FHWA-MA-EIS-82-02-F

Final Environmental Impact Statement and Final Section 4(f) Evaluation

#### Third Harbor Tunnel, Interstate 90/ Central Artery, Interstate 93

Written Comments and Responses on DEIS/DEIR, SDEIS/SDEIR, and Public Hearing is one of six separately bound volumes which constitute the Final Environmental Impact Statement/ Environmental Impact Report package for the Third Harbor Tunnel/Central Artery Project, as listed below.

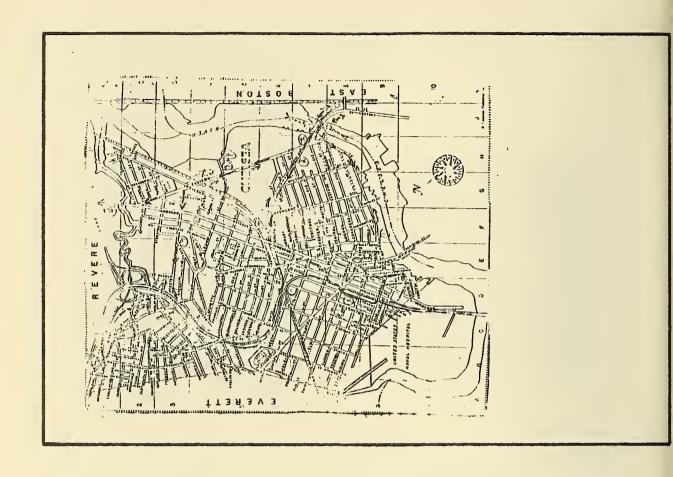
I believe that the above alternatives in conjunction with the proposed Central Artery 320jert wild eventually do the joo that nesde to be done.

I am a former East Sestonan who fraquently visits france and talesticis in East Seston ind Stuth Seston I is no Tests estat ching then by residence, not set involved in gny\_batigme, or these my interest in eny business or venture in estropolities Reston.

disruptions to these neighborhoods, both during construction and in the long term, would probably result. The proposed Third Harbor Tunnel is a gap in the Interstate Highway System, and would be designated Interstate Poute 90. portions of Route 1, particularly north of its interchange with the tunnel you propose in the "unused railroad right-of-way". The Commonvealth has rejected this option, as it does not appear to meet the objectives of the project in alignment passea are unknown at this time, although it is expected that major implications on the portions of Chelsea and East Boston through which this description and sketch that significant traffic increases would result on The suggestions in your letter for an improved north-south egress improving cross-harbor vehicle capacity and access to the Airport. The through Chelsea and East Boston are noted. It would appear from your
